**PERMIT REPORT**

Re: Minneapolis Park & Recreation Board; Permit 18-635: Lake Nokomis Shoreline

Recommendation:

1
22 SHORELINE RIPRAP STABILIZATION TYPE 1 DETAIL
NOT TO SCALE

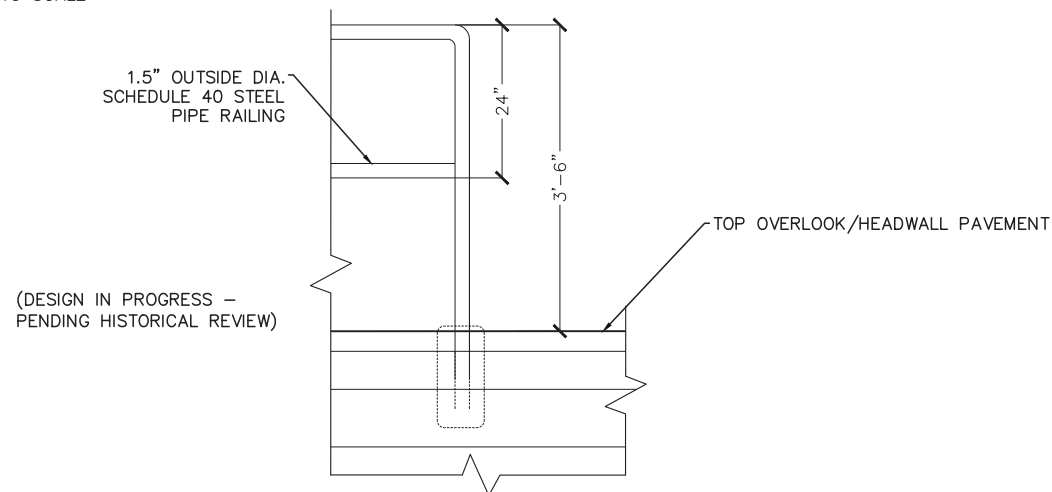
1. The maximum encroachment of riprap in “Shoreline Stabilization Style 1” shall be ten feet waterward from the Ordinary High Water Level.

- Stabilization practices are installed at a 3:1 slope or flatter where practical or feasible;
 - The Applicant has submitted plans and cross-sections showing rip-rap 2.5:1 slope due to the steep bathymetry of the shoreline. Based on staff and the District Engineer's analysis, the Applicant has met this criteria of the rule.

- The Applicant has submitted plans depicting a 2.5:1 slope, due to the steep bathymetry in the area to meet the ten foot maximum encroachment. The ten foot maximum encroachment is not specified in the plans, and is therefore included as a recommended stipulation on the permit.
